Reliability Analysis Update

Bo Zhang
Sub Regional RTEP Committee – PJM West
July 18, 2025

AEP Transmission Zone: Baseline B3333 Reactivation and Scope Change

B3333 Scope change: Redlined below

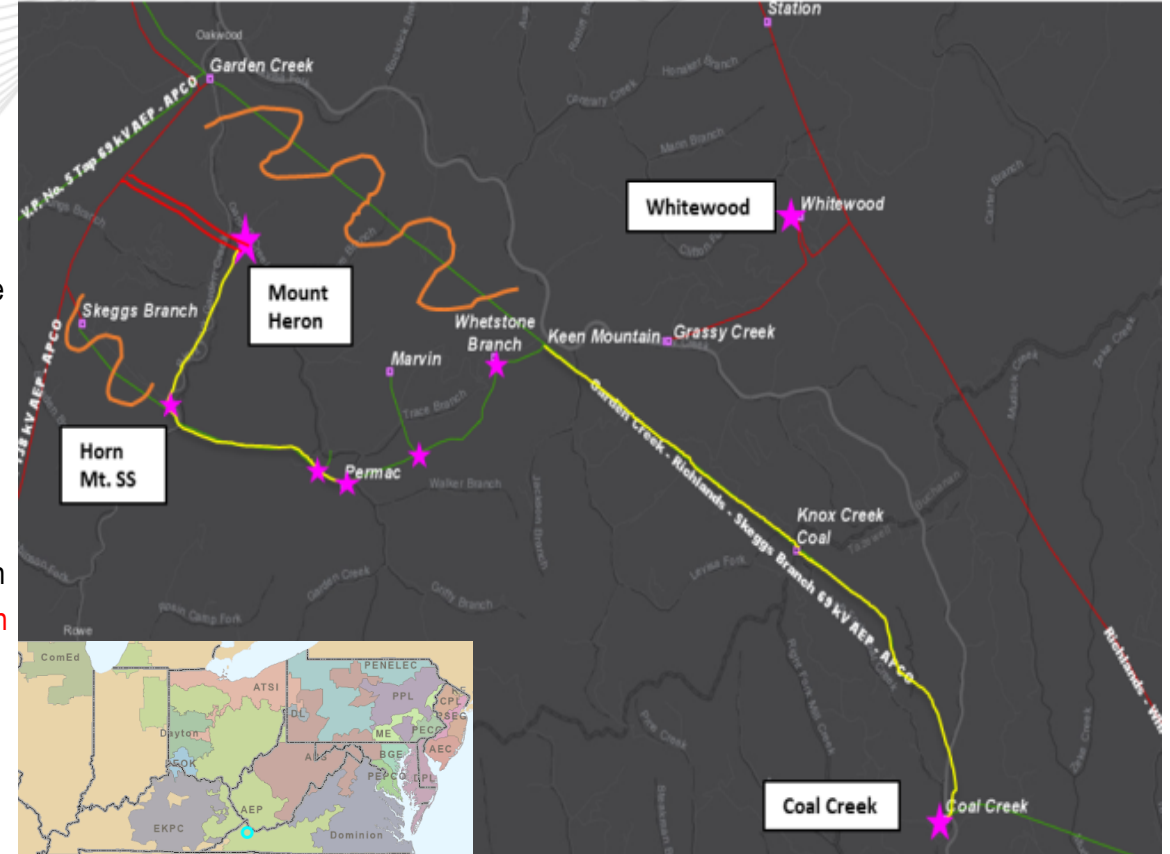
B3333: Originally presented on 8/31/2021 to address Buchanan units 1 and 2 Deactivation
Cancelled on 3/14/2025 due to Buchanan units 1 and 2 deactivation was withdrawn.
Reactivated on 7/18/2025

Reason for Reactivation: the subsequent deactivation of Buchanan units 1 and 2

Reason for the scope change: The original planned new substation land is not available, has to move the new location ~~0.4~~ 2.6 mile away.

Proposed B3333 Scope:

Rebuild Skeggs Branch substation in the clear as ~~Coronado~~ Mount Heron substation. Establish New 138kV and 69kV Buses. Install 138/69kV 130 MVA transformer, ~~two~~ 138kV breakers, 138kV Circuit Switcher, ~~two~~ 69kV breaker. Retire Existing Skeggs Branch substation **(B3333.1) ~~\$6.345M~~ \$9.935M**

New ~~~1.2~~ 1.6 mi double circuit 138kV extension to new ~~Skeggs Branch~~ Mount Heron substation location and work required to tap the Clinch River – Garden Creek 138kV line. Retire the existing Skeggs Branch 138kV Tap **(B3333.2) ~~\$4.62M~~ \$19.144M**

Install ~~43.2~~ 57.6 MVAR Cap bank at Whitewood along with 138kV breaker. **(B3333.3) ~~\$1.05M~~ \$2.765M**

Rebuild ~9 mi 69kV line from ~~new Skeggs branch station~~ Horn Mountain SS to Permac switch. Rebuild from Str. 340-28 to Coal Creek station. **6-wire the short double circuit** section between Whetstone Branch and Str. 340-28 to convert the line to single circuit. **Retire** Garden Creek to Whetstone Branch 69kV line section. **(B3333.4) ~~\$26.25M~~ \$45.304M**

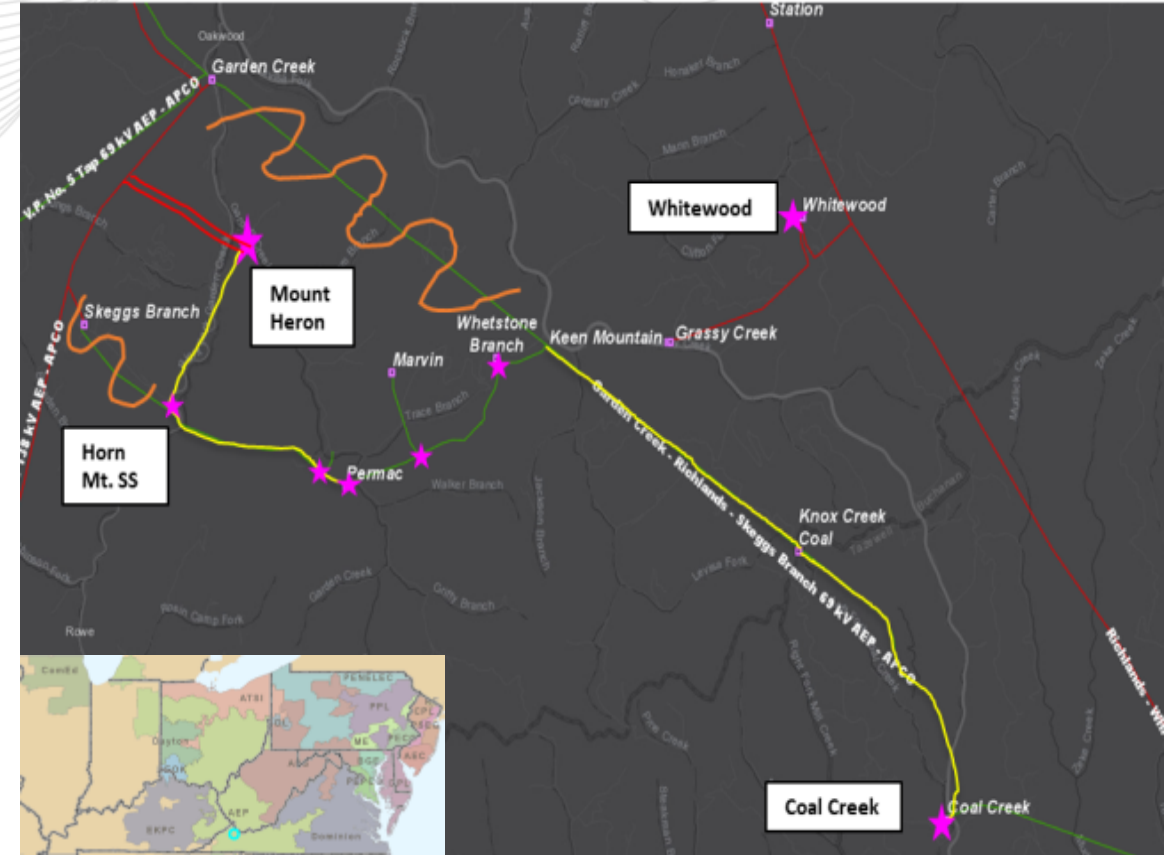
Retire Knox Creek SS. (B3333.5) \$ 0.06 M

Horn Mountain SS, ~~This will be served directly from 69kV bus at New Skeggs branch Substation.~~
Replace 600A Switch and structure with 3 Way 1200A POP Pole Switch and pole. (B3333.6) ~~\$0.05 M~~ \$1.987M

At Clell SS, Replace (2) 600A POP Switches and Poles with single ~~2~~ 3 Way 1200A POP Switch and Pole.(B3333.7) ~~\$0.34M~~ \$1.796M

At Permac, Replace 600A Switch and structure with 2 Way 1200A POP Pole Switch and pole. (B3333.8) ~~\$ 0.31 M~~ \$2.503M

At Marvin SS, Replace 600A Switch and structure with ~~2~~ 3 Way 1200A POP Pole Switch and pole. (B3333.9) ~~\$ 0.31 M~~ \$2.688M

At Whetstone Branch substation, Replace 69KV 600A 2 Way POP Switch with 69KV 1200A 2 Way POP Switch. Remove 69KV to Skeggs Branch (Switch "22" POP). (B3333.10) ~~\$ 0.568 M~~ \$1.695M

At Garden Creek substation, Remove 69KV Richlands (via Coal Creek) line (Circuit Breaker F and disconnect switches) and update relay settings. (B3333.11) ~~\$ 0.138 M~~ \$0.537M

Remote End work at Clinch River substation. (B3333.12) \$0.08 M

Remote End work at Clinchfield substation. (B3333.13) \$0.08 M

Install ~2.6 mi greenfield 69kV line from greenfield Mount Heron station to the existing Horn Mountain S.S. \$18.015M

Total Estimated Cost: ~~\$40.171 M~~ \$106.589M

Projected IS Date: ~~12/15/2023~~ 12/10/2027

Alternative:

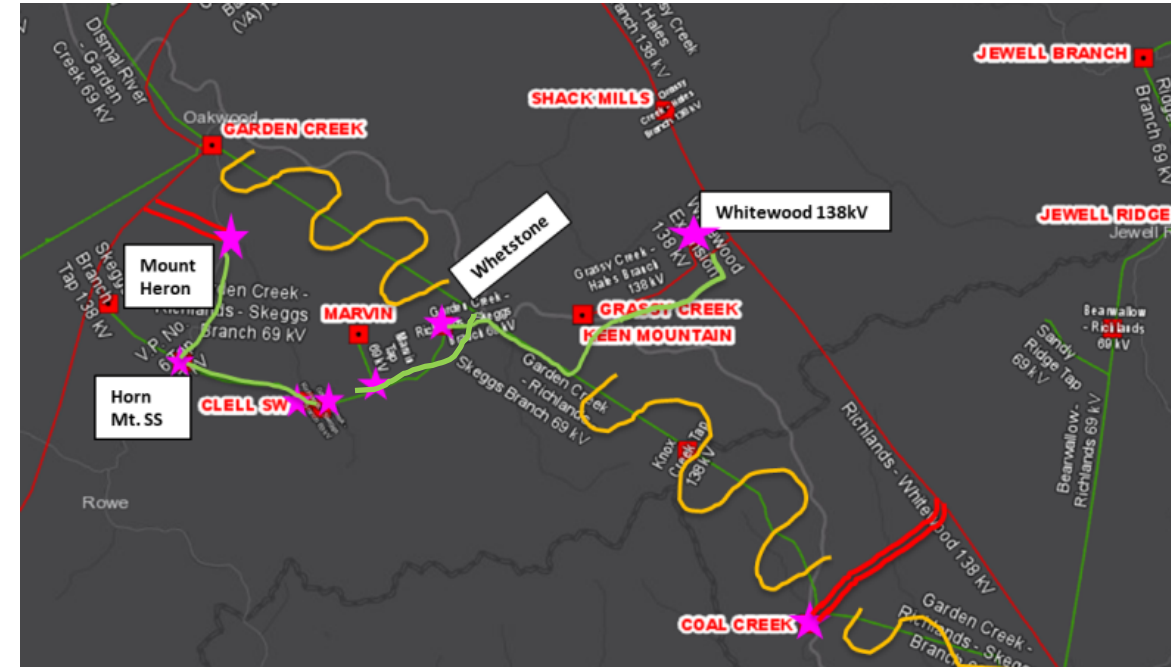
- Establish Mount Heron substation. – This station scope is identical to the proposed project.
- New Greenfield 69kV line between Mount Heron to Horn Mountain 69kV switch. – This scope is identical to the proposed project.

- Replace switches at Horn Mountain, Permac, Marvin. – This scope is identical to the proposed project.
- Rebuild 69kV line between Horn Mountain to Clell SS. – This scope is identical to the proposed project.

- Retire the Garden Creek – Whetstone Branch 69kV line section. – This scope is identical to the proposed project.
- Install a 69kV capacitor bank at Mount Heron station.

- Retire Whetstone Branch – Richlands 69kV line. ~11.5 miles.
- Establish new 138kV Coal Creek substation. Install new 138/12kV 20 MVA transformer along with related distribution equipment. Convert customer feed to 138kV. Install new revenue metering for this customer.

- Cut into Whitewood – Richlands 138kV line. Install ~2.5 mi 138kV double circuit line from the line cut in location to new Coal Creek 138kV substation.

- Install 138/68/12kV 130 MVA transformer along with a 138kV and 69kV circuit breaker at Whitewood station.
- New ~5 mi Greenfield 69kV line between Whitewood and Whetstone Branch substations.

Cost comparison:

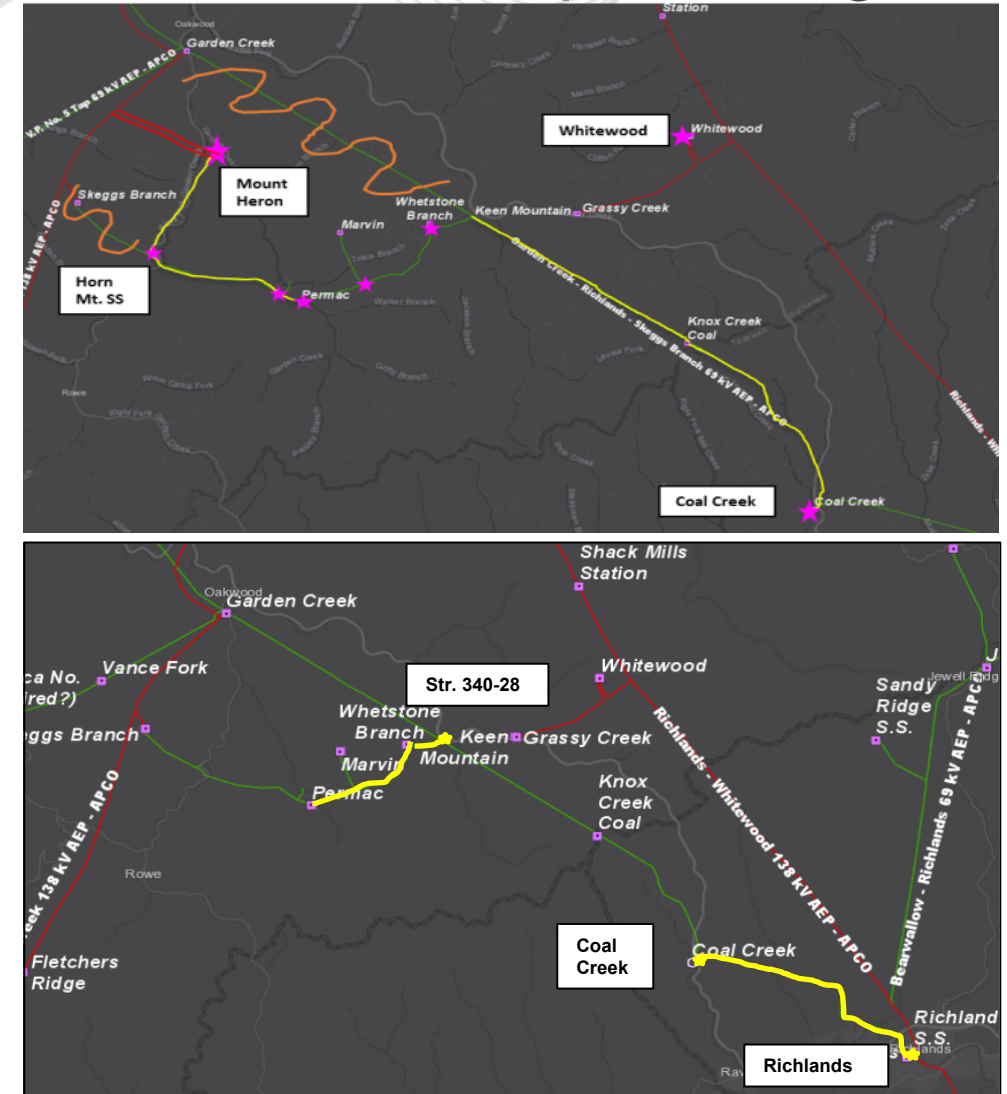
- The cost for B3333 is \$106.589M and the cost for S3135 (TEAC 11/17/2023, projected IS 10/30/2027) is \$29.2M. The total cost for the holistic solution is \$135.789M.
- The conceptual estimate for the alternative holistic solution is \$142.57M.
- Modifying solutions will impact the timeline.
